Duke DR1 to NCSEA, CCEBA, and SACE et al.
Docket No. E-100, Sub 165
2020 IRP
Item No. 1-1
Page 1 of 1

Please provide all analyses, workpapers, assumptions, model inputs and outputs upon which Synapse Energy Economics, Inc. (“Synapse”) relied upon or which support the “Mimic Duke” and “Reasonable Assumptions” scenarios modeled or analyzed in making any of the assertions in their report “Clean, Affordable, and Reliable A Plan for Duke Energy’s Future in the Carolinas” (Exhibit A to your Partial Initial Comments on DEC and DEP’s 2020 IRPs).

Overstated Nuclear Capacity Modeled in the Synapse Study

FIGURE H-8

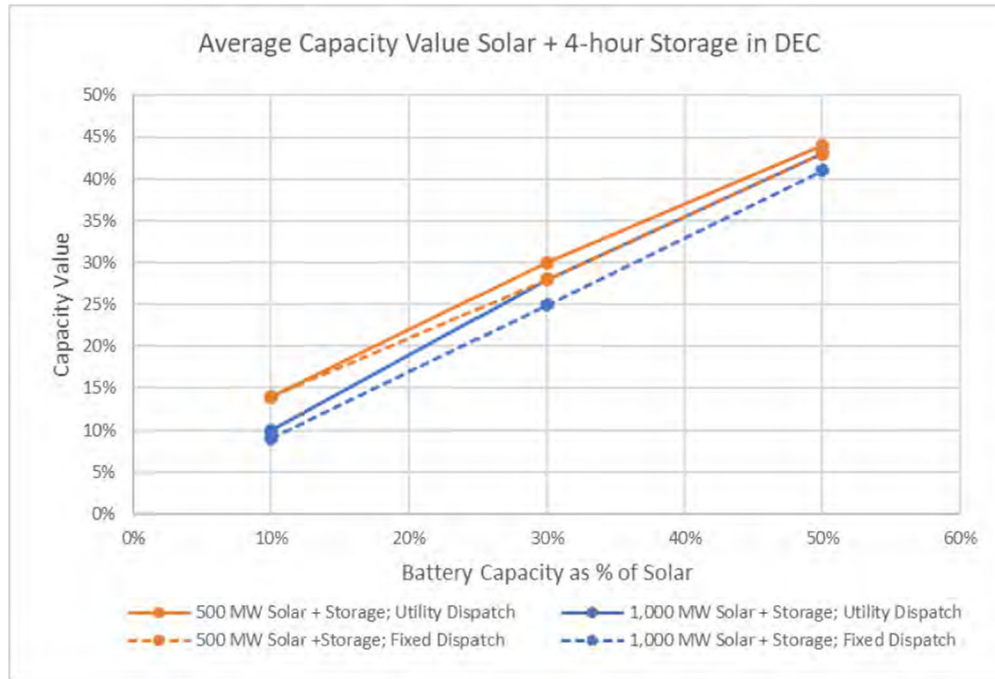
The amount by which the Synapse Study overstates nuclear capacity.

Modeling Impacts - Significance of Flawed Assumption (Capacity)

Overstated Nuclear Capacity Modeled in Synapse Study (MW): ¹	1,707
Overstated Nuclear Capacity Equivalency of Robinson Nuc Unit (793 MW):	2.2
Overstated Nuclear Capacity Equivalency of Solar plus Storage (MW): ²	6,828

¹Reflects Synapse modeling Co-Owners' Share of Catawba 1&2 and slight differences in unit ratings.

²Assumes solar plus 4-hour duration storage, 25% storage to solar ratio and 25% effective load carrying capability (ELCC).

Storage to solar ratio	25%
ELCC for Solar+Storage used in IRP	25%
Overstated winter CNS Capacity	1707
Solar + storage MW required to replace overstated Catawba capacity (MW)	6,828
